Public Comments
of
Pilkington North America, Inc. (PNA)
to the
U.S. Department of Energy's
Energy Star Program's
Windows, Doors, and Skylights Revised Draft Criteria and Report

Submitted November 14, 2008
Public Comments of Pilkington North America, Inc.
to the
U.S. Department of Energy's
Energy Star Program's
Draft Report of Criteria and Analysis for Windows, Doors, and Skylights

APPENDIX A
Showing Average Annual Home Energy Consumption ES 3
Using 0.35 and 0.30 U-factor and SHGC from 0.00 to 0.70

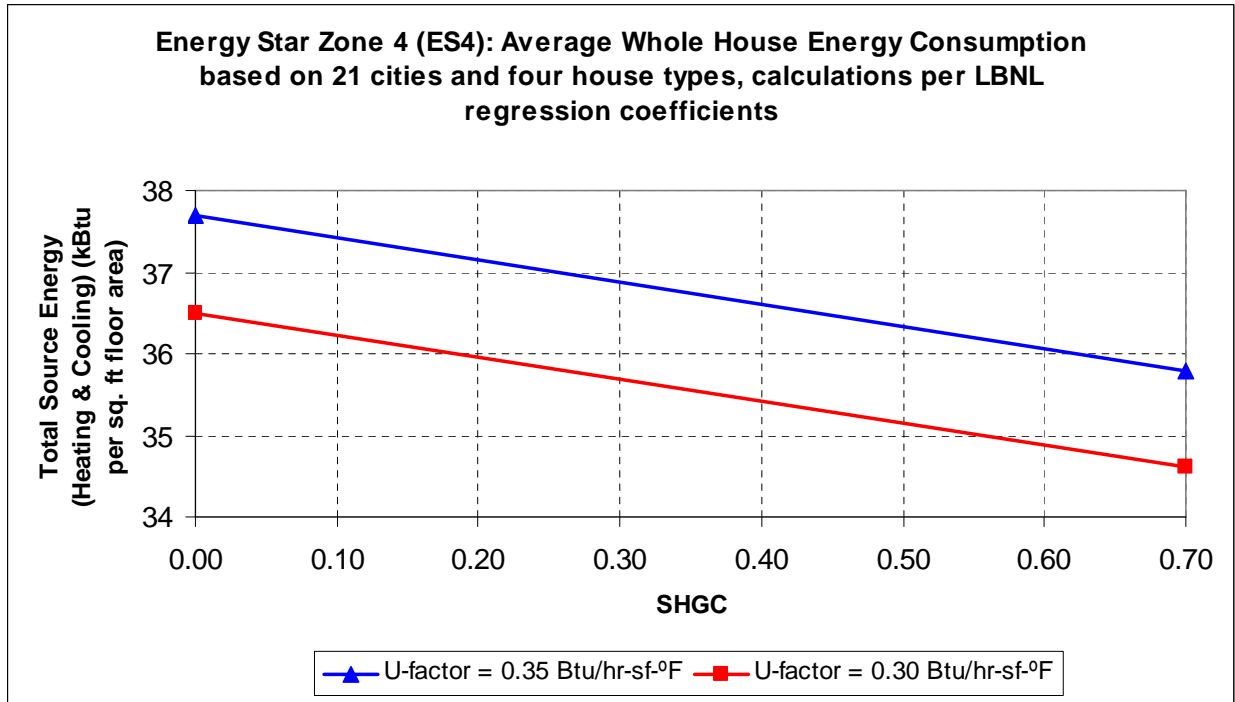
Appendices A, B and C attached hereto, graph the average energy consumption of homes in ES 3, 4 and 5, respectively. These graphs use the same cities and the same regression coefficients used to develop the current Energy Star Report. Each graph plots energy consumption against windows having 0.30 and 0.35 U-factors, respectively, and against windows having SHGCs ranging from 0.00 to 0.70. As can be seen on each of the three (3) attached graphs, **as SHGC increases in ES 3, 4 and 5, total annual energy consumption decreases.** The further north you go, from ES 3 to ES 5, the larger, or steeper, the decrease in total average energy consumption.

APPENDIX B
Showing Average Annual Home Energy Consumption ES 4
Using 0.35 and 0.30 U-factor and SHGC from 0.00 to 0.70

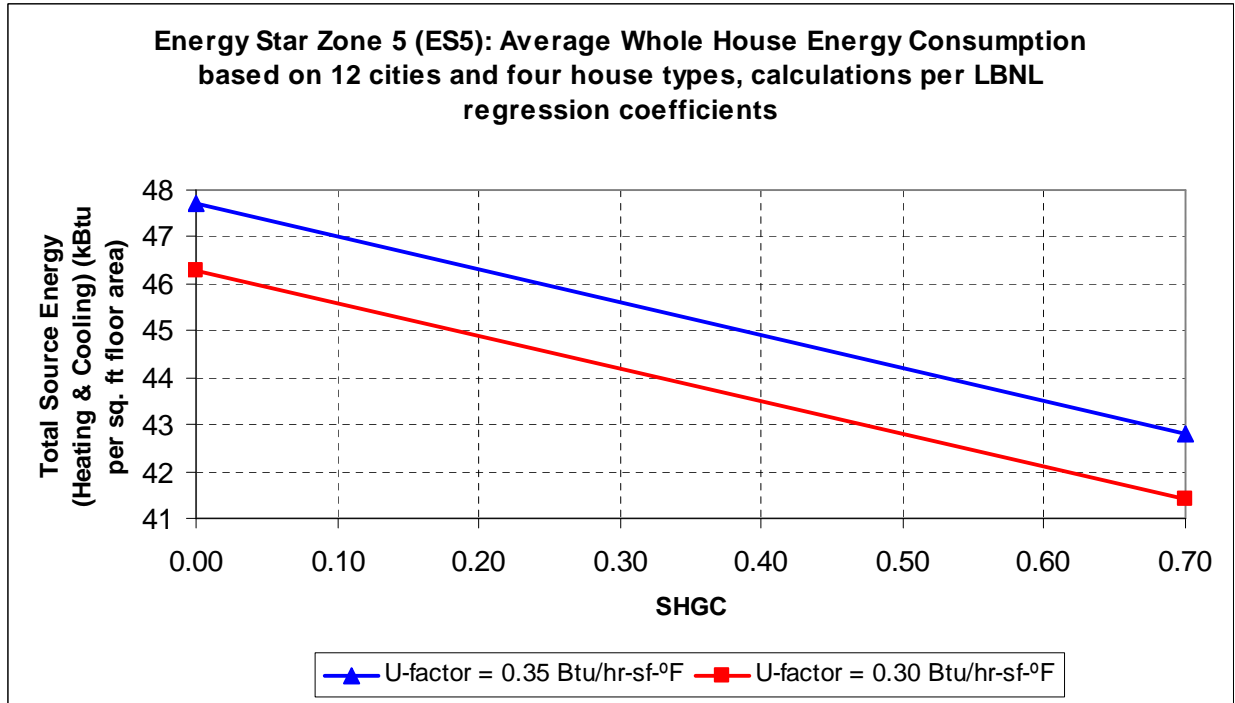
Nowhere in the Energy Star Report is there reference to any objective evidence of any kind to support DOE's proposed inclusion of a 0.55 SHGC cap in ES 4 or 5 in Phase 1 or Phase 2. In fact, the objective evidence is to the contrary. **SHGC levels above the proposed 0.55 cap will save more energy than SHGC levels below the proposed 0.55 cap in ES 4, and will save even more energy in ES 5.** See, Appendices B and C attached hereto.

4. The Energy Star program is "designed to help reduce national energy consumption by increasing the energy efficiency of fenestration products in residential buildings." Energy Star Report, p. 4. As demonstrated in Appendices B and C, eliminating the 0.55 SHGC cap in ES 4 and 5 will achieve the objective of reducing national energy consumption.

There is no legitimate basis for the imposition of a 0.55 SHGC cap and it will arbitrarily disqualify energy efficient products from qualifying for an Energy Star label. The 0.55 SHGC cap should be eliminated from the Phase 1 and 2 criteria for ES 4 and 5.
